Raymore City Council Work Session
City Hall – 100 Municipal Circle
Monday, December 2, 2019

Re: Adoption of 2018 International Building Codes

The Committee is recommending that City Council adopt the 2018 series of International Codes and adopt the new Chapter 500: Building Regulations of the Raymore City Code.

Figure R908.3 Hail Exposure Map

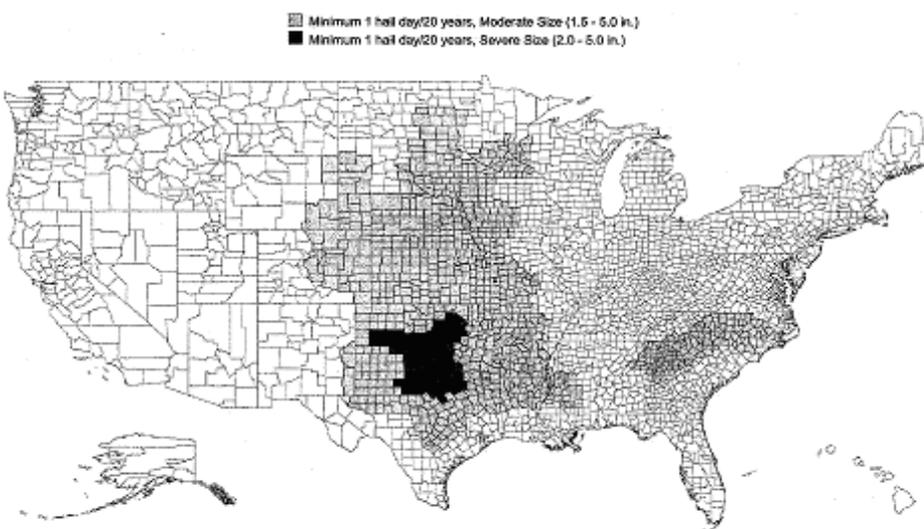
4. For asphalt shingles, when the building is located in an area subject to moderate or severe hail exposure according to Figure R908.5, a repair of five (5) percent or less of the total roof covering in any three (3) year period may utilize approved roofing materials comparable to the existing roofing materials.
